GAS MEMBRANE VALIDATION

Site Name: Belle Vue	Project Number: 12-123
Company Name: Countryside Properties	Date: 05-10-2022
Project Manager: S. Ellis	E3P Engineer: T. Preston
PM Qualifications: BSc (Hons), FGS, Cenv	Engineer Qualifications: Verification of Gas Protection Systems July 18
Ground Gas Risk Assessment: Amber 1	
<p>Overview:</p> <p>The membrane comprised a Visqueen low permeability gas membrane (Yellow) resistant to radon, carbon dioxide and low levels of methane. E3P can confirm there were no holes or rips at the time of inspection. Upon being laid the membrane is to be covered with a Celotex (closed Cell) floor insulation material which is considered to provide a high degree of protection.</p> <p>All external joints were inspected and E3P can confirm that the membrane was overlapped and double taped to external and internal gas resistant DPM. The membrane was taped to the gas resistant DPM using a double-sided jointing tape. All the overlaps were then additionally taped using foil backed girth tape.</p> <p>Each unit has a service duct located to the front and outer edge of the property. E3P inspected each one and can confirm that the top-hats have been adequately sealed

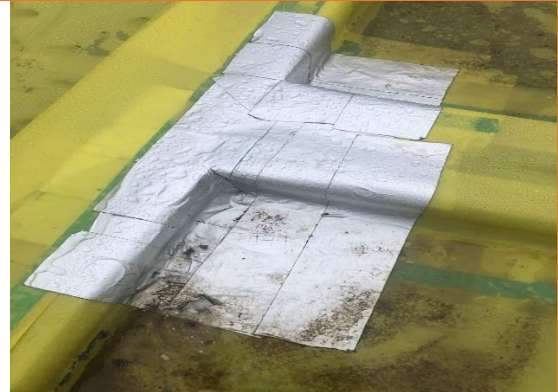
General Condition of Membrane-Good Condition

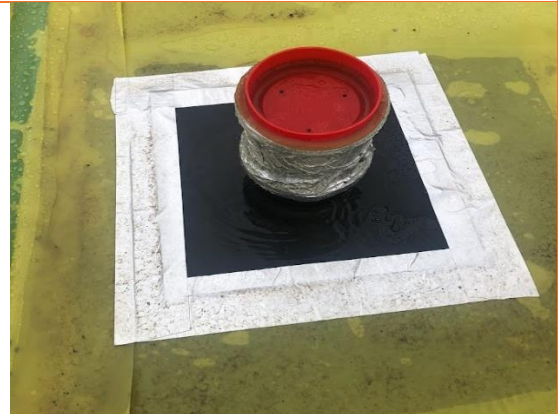
Verification of Joints and Seals-Good Condition

Plot - 170

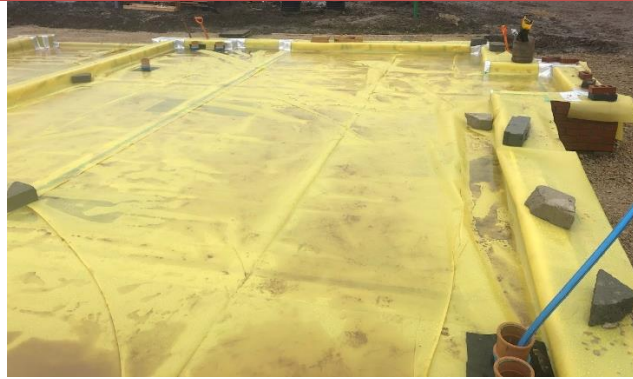
General Condition of Membrane-Good Condition

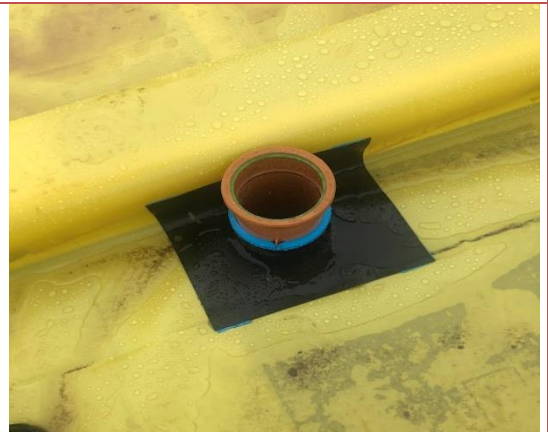
Verification of Joints and Seals-Good Condition
